CHATEAUGUAY PLACE SUBDIVISION,
MCPHILLIPS ADDITION TO

APPLICATION NUMBER 13 DATE November 1, 2007

REQUEST Subdivision

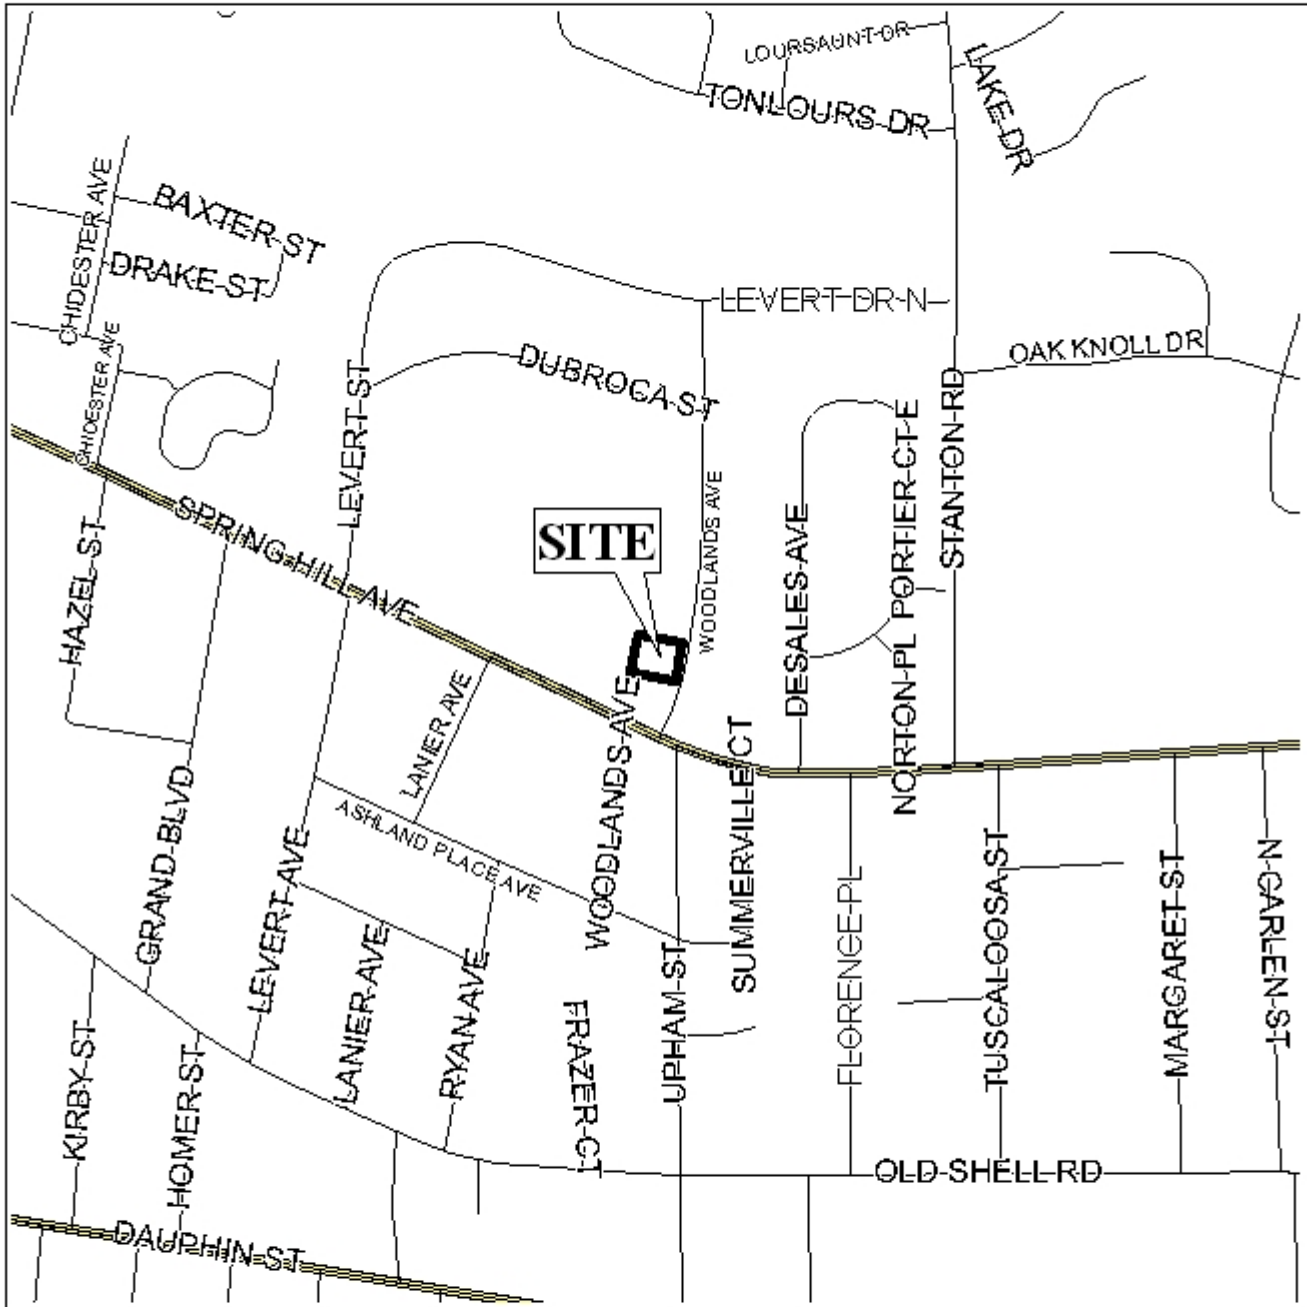
The site fronts Woodlands Avenue, a minor street as illustrated on the major street plan and is in compliance with the minor street requirements of the plan. Since this is a single-family residential lot, the placement of a note on the Final Plat limiting the lot to the existing curb cut would be appropriate.

The proposed lot is not labeled with the square footage, which should be placed on the Final Plat.

The placement of the 25-foot minimum building setback line along Woodlands Avenue should also be required on the Final Plat.

- 1) labeling of the lot with its size in square feet, or the provision of a table on the final plat with the same information;
- 2) placement of a note on the final plat stating that the site is limited to one curb cut, with the size, location, and design to be approved by Traffic Engineering, and conform to AASHTO standards; and
- 3) the placement of the 25-foot minimum building setback lines on the Final Plat.
